Memorandum

Subject: Parker and Pine Filing 1 Lot 2 Gas Station – Engineering 2nd Review

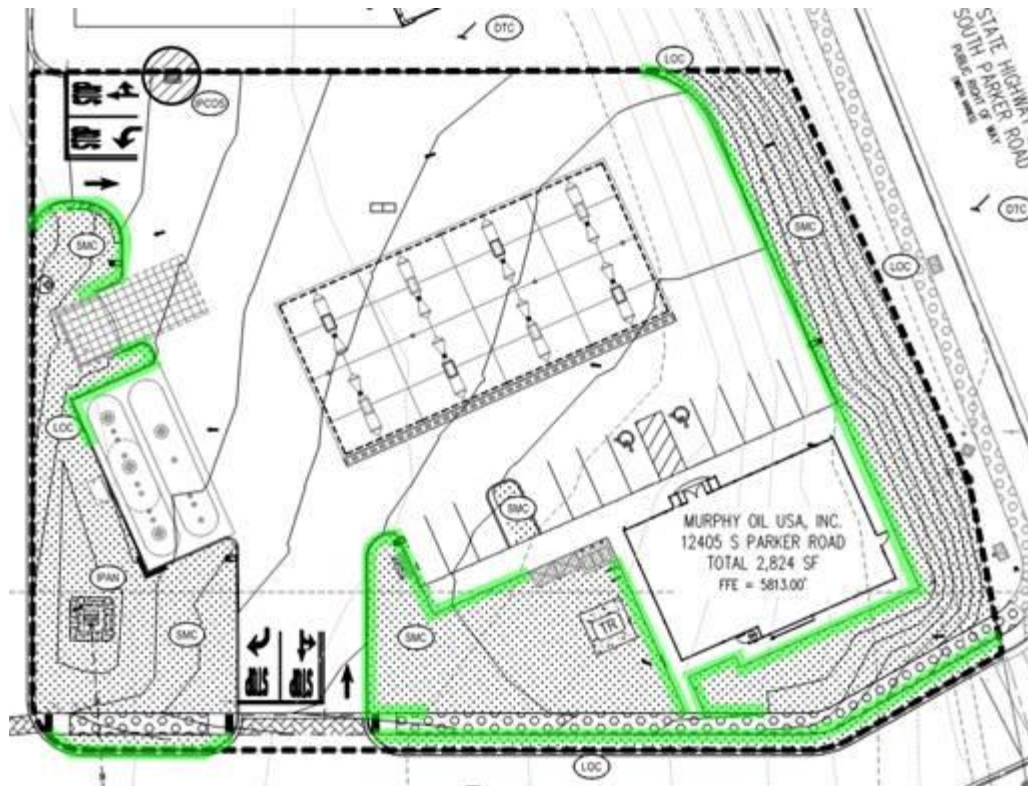
12. Include within the plan set all of the town's 31 CBMP Notes & Details – even those not currently proposed on the CBMP plans.
13. Add a callout/label on all properties adjacent to the project stating that no work shall occur in these areas.
